NPP BORSSELE LTE PHASE 1
ENVIRONMENTAL IMPACT
ASSESSMENT

Expert Statement

REPORT
REP-0931

VIENNA 2024

Figure 1:
The declining costs of renewables versus traditional power sources

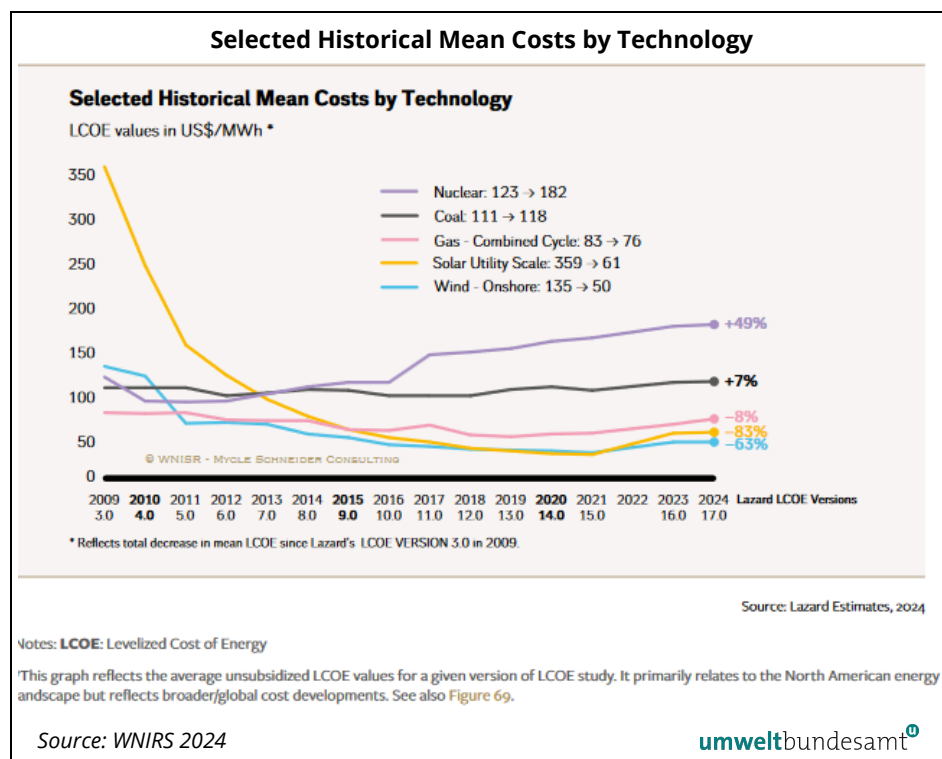
The claim of the EIA Report that nuclear energy is not more expensive than renewable sources such as wind and solar, is no longer true, as the following figure from the latest World Nuclear Industry Status Report summarises.

Not only the costs for NPP new build but also for lifetime extension should not be described as one of the cheapest and fastest ways of continuing to generate CO₂-free electricity without presenting any studies in this regard.

Figure 2:
Implementation of the
2020 WENRA RL Status 1
January 2024 (WENRA
2024a)

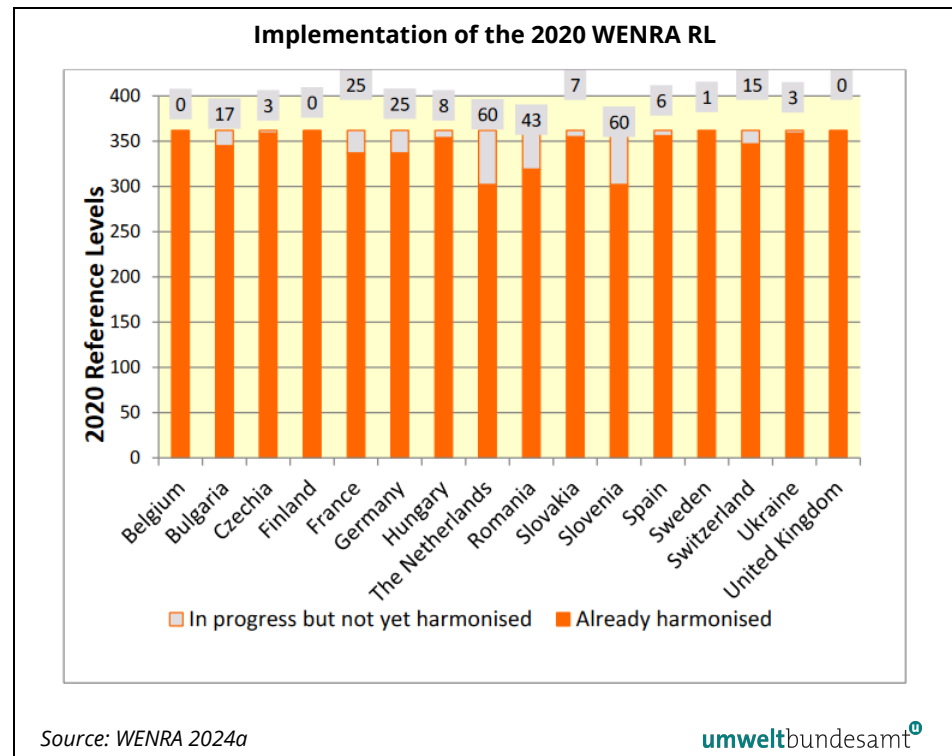
Figure 2 shows that the Netherlands 60 RL has not implemented yet. The implementation should be regarded as a prerequisite for a possible lifetime extension but should also be made mandatory in the procedure for amending the Atomic Energy Act. The safety of a plant can only ever be measured against the relevant regulations. Since there are no requirements for the important safety aspects such as ageing and protection against internal fires in the Dutch regulations in line with the state of the art, it cannot be guaranteed that the safety level of the plant corresponds to the current state of the art.

Figure 3:
Trends in core melt frequency (EIA REPORT
2024)

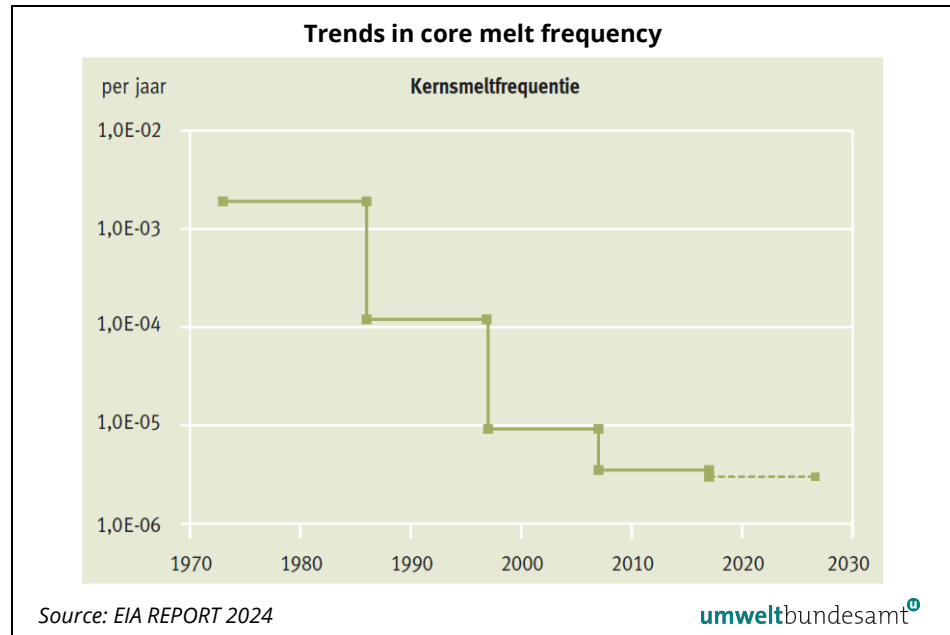
The back-fitting measures have improved the safety of the Borssele NPP and reduced the risk of accidents. This can be seen from the PSA results, where the frequency of core damage has been significantly reduced (see Figure 3).

Figure 4: Weather-related deposition with Cs-137 in Bq/m² by a severe accident at Borssele. Source: <https://flexrisk.boku.ac.at/en/evaluation.phtml#form>

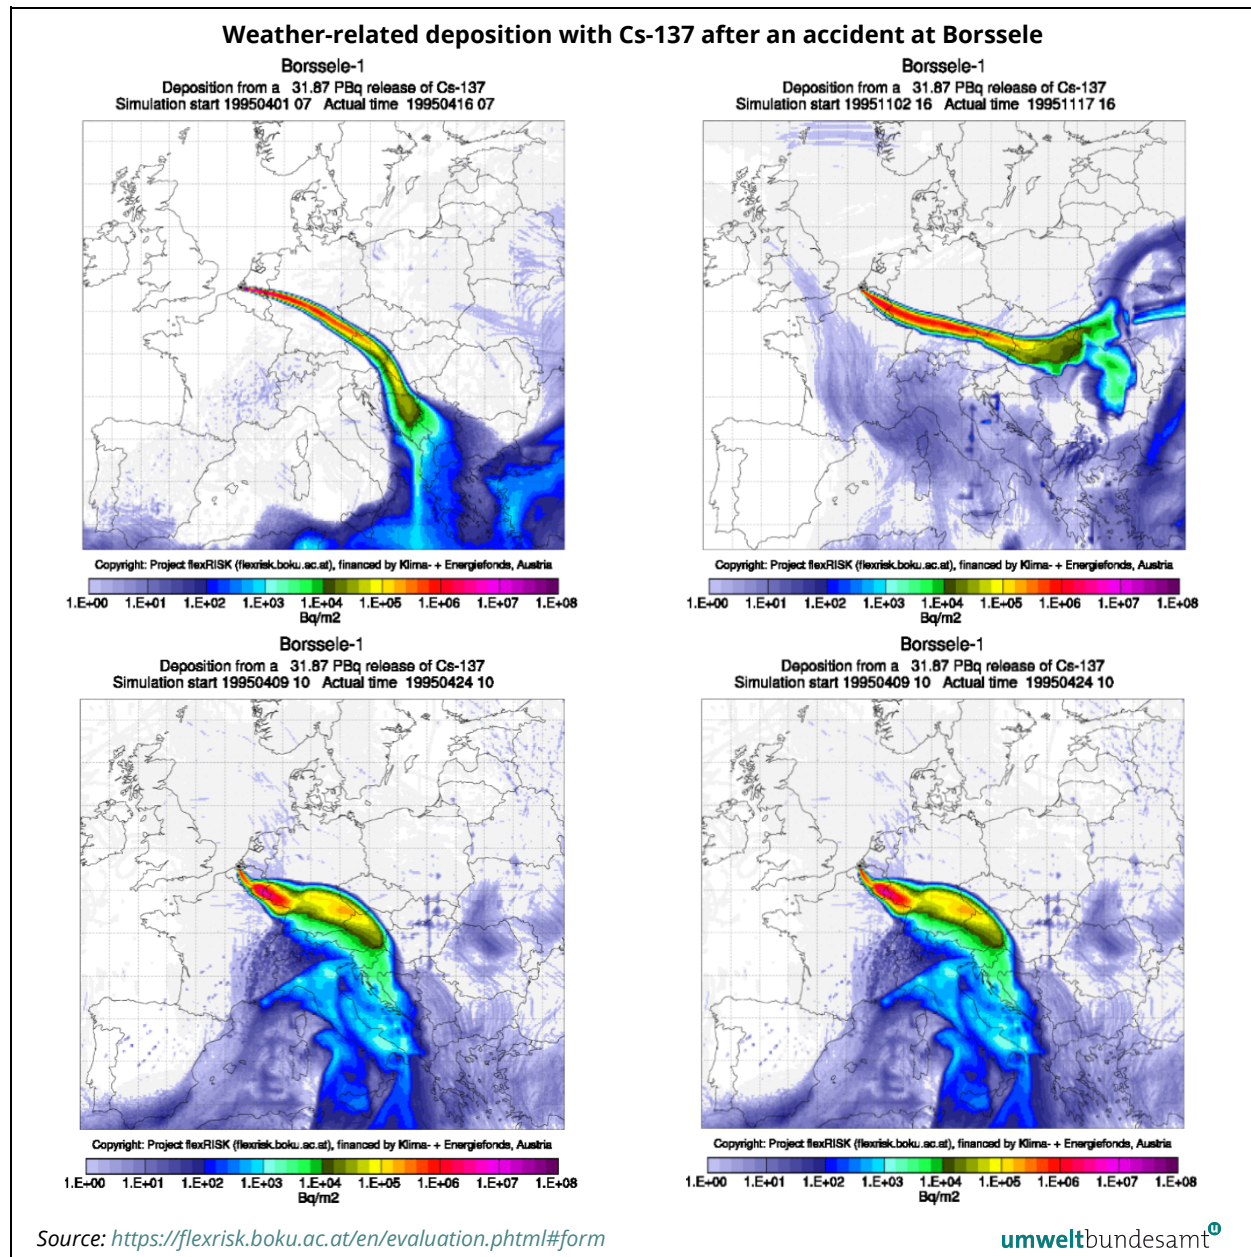
This flexRISK figure shows four different weather situations in which Austria could be severely contaminated by this assumed accident in Borssele. The contamination could reach up to a few hundred kBq/m² (light red colour).

Figure 5:
Weather-related probability for a contamination exceeding 5 kBq Cs-137/m² by a severe accident at Borssele. Source: <https://flexrisk.boku.ac.at/en/evaluationAggUnit.phtml#form>

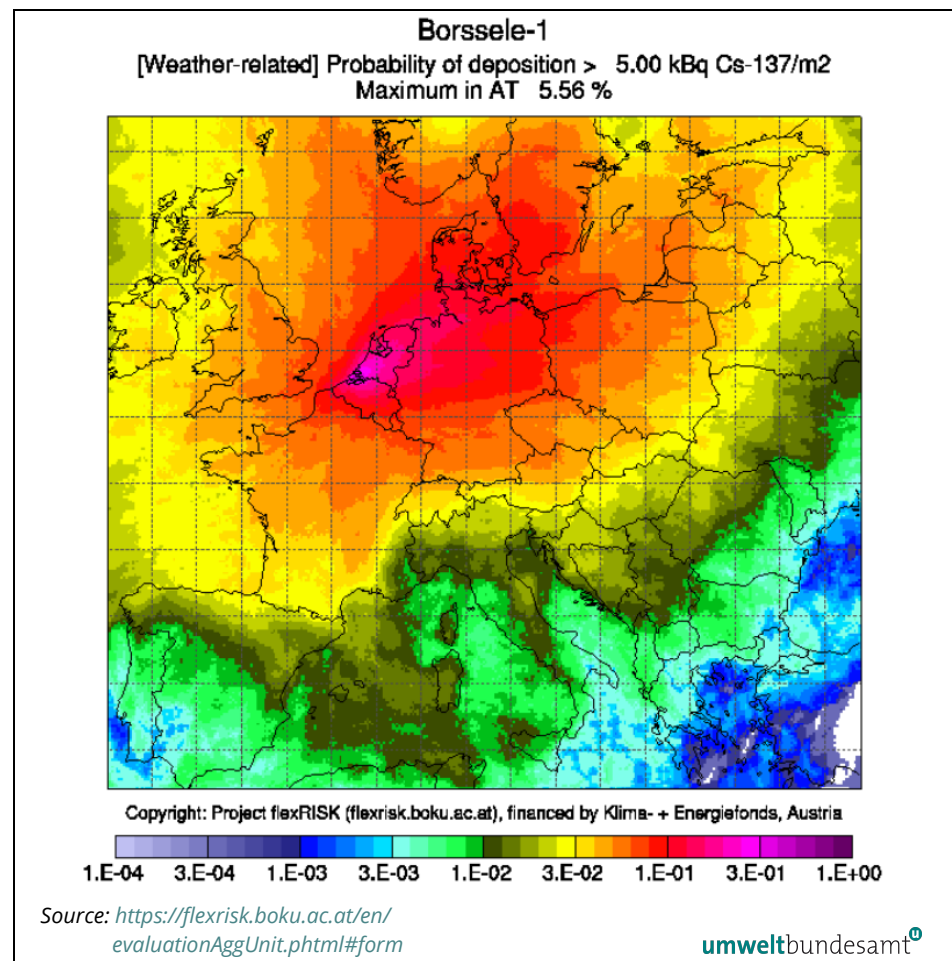
These probabilities might be low, but in Austria even lower contamination triggers agricultural countermeasures. These measures include earlier harvesting, closing of greenhouses and covering of plants, putting livestock in stables etc. A catalogue of countermeasures for radiological crisis situations is used, which requires the introduction of agricultural protection measures even in the case of low levels of contamination (MASSNAHMENKATALOG 2022). This catalogue includes, among others, measure V06 ("Immediate harvesting of marketable products, in particular of storable products") with its associated (forecast) levels:
